# **SERVICE BULLETIN**

GLOBAL AFTER SALES OFFICE, MITSUBISHI MOTORS CORPORATION

PURP	POSE: Modifications	ISSUE NO.: MSB-16EXML42_52_54-001	DATE: 2016-11-21	
SUBJ	ECT: Modifications of t and additional co	<destination model=""> (As per attached sheet 1)</destination>	<m y=""> ~17</m>	
GROU	UP : Gr:42(Body)/52(Inter	As per attached sheets 2 & 3

## TAIL LAMP, POSITION LAMP, LICENCE PLATE LAMP AND LIGHTING MONITOR BUZZER

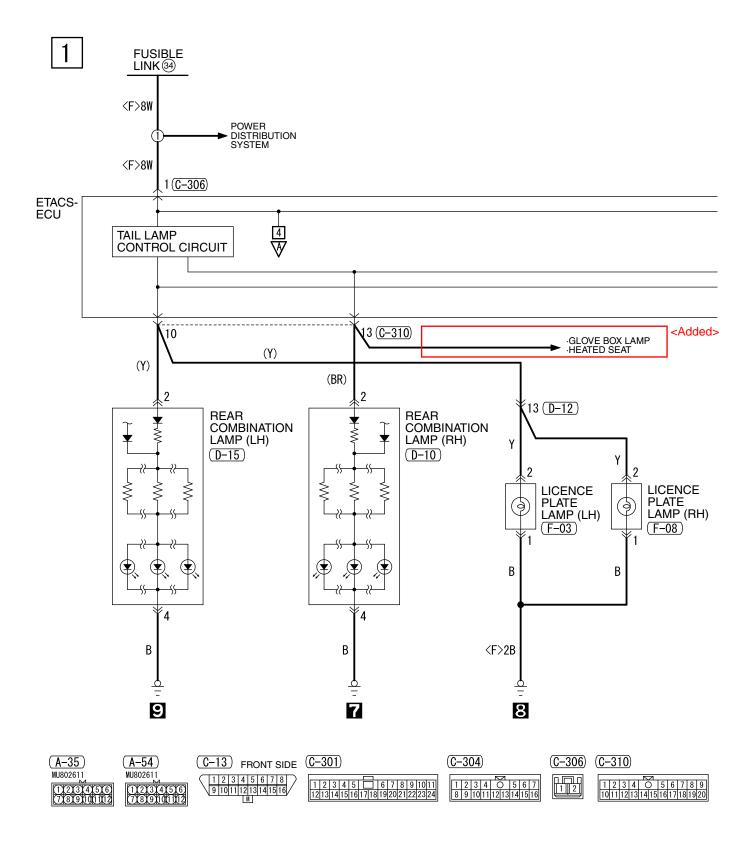
GROUP 54A: Code No. B16AO Tail lamp(RH) circuit open, Code No. B16A7 Tail lamp(RH) circuit short NOTE: Due to a design change, the DTC "B16AO" will not be anymore from 12MY.	Attached sheet 5 (2/22) ~ (7/22)
OUTLANDER (GF#)	<pre><initial -="" 17my="" launch=""> Workshop Manual</initial></pre>	GROUP 13, 17, 23, 27, 35, 36, 37, 42, 52, 54, 55: Code No. U0141 ETACS CAN timeout	Attached sheet 5 (1/22)
		GROUP 54A: Code No. B16A7 Tail lamp(RH) circuit short	Attached sheet 5 (10/22) ~ (14/22)
		GROUP 90: TAIL LAMP, POSITION LAMP, LICENCE PLATE LAMP AND LIGHTING MONITOR BUZZER	Attached sheet 5 (15/22)
		GROUP 90: GLOVE BOX LAMP AND FLOOR CONSOLE BOX LAMP	Attached sheet 5 (16/22)
OUTLANDER PHEV (GG#)	<initial -<br="" launch="">17MY&gt; Workshop Manual</initial>	GROUP 13, 17, 23, 27, 35, 36, 37, 42, 52, 54, 55: Code No. U0141 ETACS CAN timeout	Attached sheet 5 (1/X)
		GROUP 54A: Code No. B16A7 Tail lamp(RH) circuit short	Attached sheet 5 (17/22) ~ (22/22)

GROUP 90: TAIL LAMP, POSITION LAMP, LICENCE PLATE LAMP AND LIGHTING MONITOR BUZZER	Attached sheet 5 (15/22)
		GROUP 90: GLOVE BOX LAMP AND FLOOR CONSOLE BOX LAMP	Attached sheet 5 (16/22)

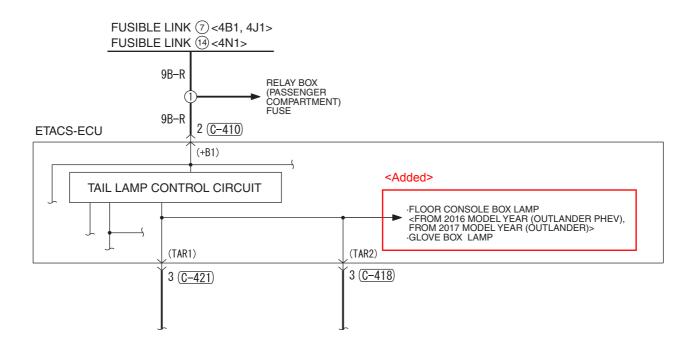
Note: The circuit diagram above shows 2017 model year OUTLANDER as a typical circuit.

## GLOVE BOX LAMP AND FLOOR CONSOLE BOX LAMP

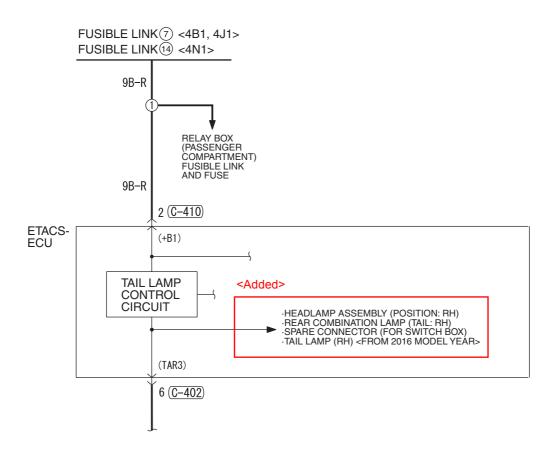
Note: The circuit diagram above shows 2017 model year OUTLANDER as a typical circuit.

#### **HEATED SEAT**

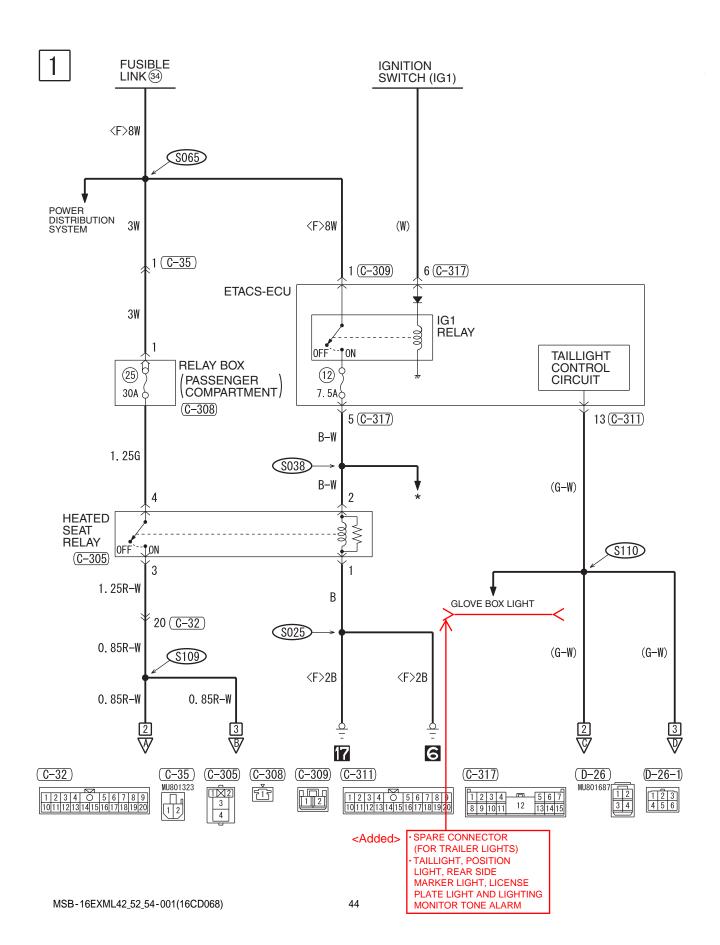
GROUP 90:	Attached
		GLOVE BOX LIGHT	sheet 6
			(18/27)
		GROUP 90:	Attached
		HEATED SEAT	sheet 6 (19/27)
OUTLANDER SPORT/RVR (GA#)	<initial -<="" launch="" td=""><td>GROUP 13, 23, 27, 35, 36, 37, 42, 52, 54, 55 :</td><td>Attached</td></initial>	GROUP 13, 23, 27, 35, 36, 37, 42, 52, 54, 55 :	Attached
	17MY> Service Manual	DTC U0141: ETACS CAN timeout	sheet 6 (1/27)
		GROUP 54A:	Attached
		DTC B16AO: Taillight (RH) circuit open,	sheet 6
		DTC B16A7: Taillight (RH) circuit short	(2/27) ~
		NOTE: Due to a design change, the DTC "B16A0" will not be anymore from 12MY.	(16/27)
OUTLANDER (GF#)	<pre><initial -<="" launch="" pre=""></initial></pre>	GROUP 13, 17, 23, 27, 35, 36, 37, 42, 52, 54,	Attached
COTE/MDER (di #)	17MY>	55:	sheet 6
	Service Manual	DTC U0141: ETACS CAN timeout	(1/27)
		GROUP 54A:	Attached
		DTC B16A7: Taillight (RH) circuit short	sheet 6 (20/27) ~ (25/27)
		GROUP 90:	Attached
		TAILLIGHT, POSITION LIGHT, SIDE MARKER LIGHT, LICENSE PLATE LIGHT AND LIGHT REMINDER TONE ALARM	sheet 6 (26/27)

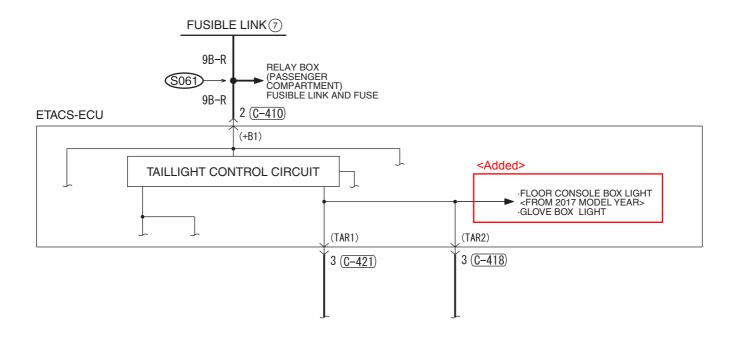
Note: The circuit diagram above shows 2017 model year as a typical circuit.

#### **GLOVE BOX LIGHT AND FLOOR CONSOLE BOX LIGHT**

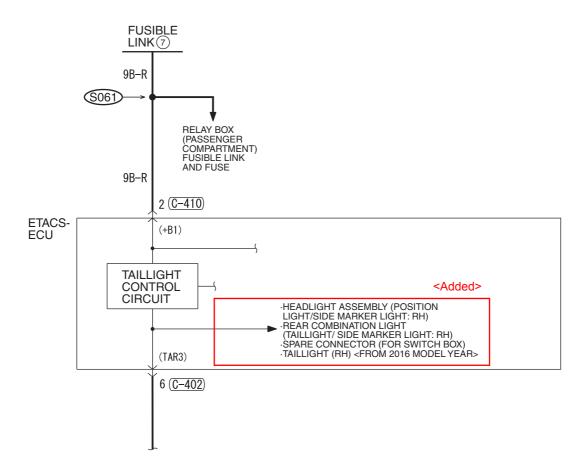
Note: The circuit diagram above shows 2017 model year as a typical circuit.
